ILLINOIS POWER COMPANY

Docket No. 50-461

Subject: Clinton Power Station
Quality Assurance Organization

FIGURE 1-3

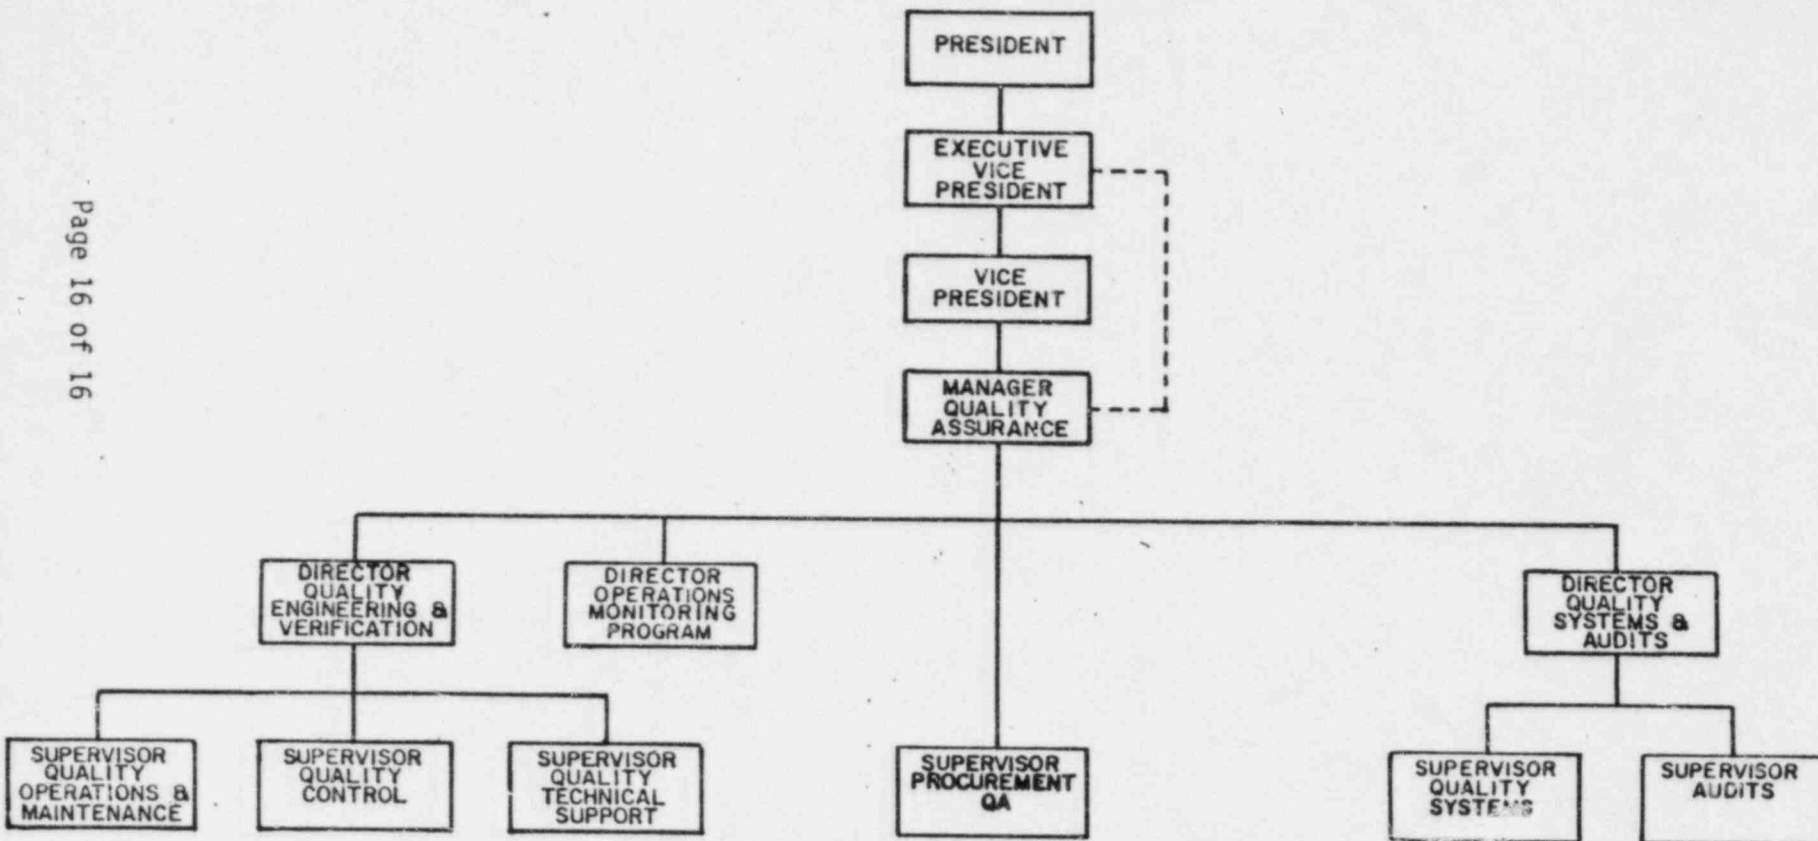
In Clinton Power Station (CPS) Final Safety Analysis Report (FSAR) Amendment 38, organizational changes were made within Section 17.2 as a result of Revision 16 to the Illinois Power Operational Quality Assurance (QA) Manual. Among the changes made were the deletion of the Director - Construction and Procurement QA, Supervisor - Construction QA and the QA Administrative Section.

Although the FSAR text was updated, the corresponding figure which shows the QA organizational chart, FSAR Figure 17.2-2, was not updated in Amendment 38. This figure will be updated in the next FSAR Amendment to correspond to Figure 1-3 of the Operational QA Manual (attached).
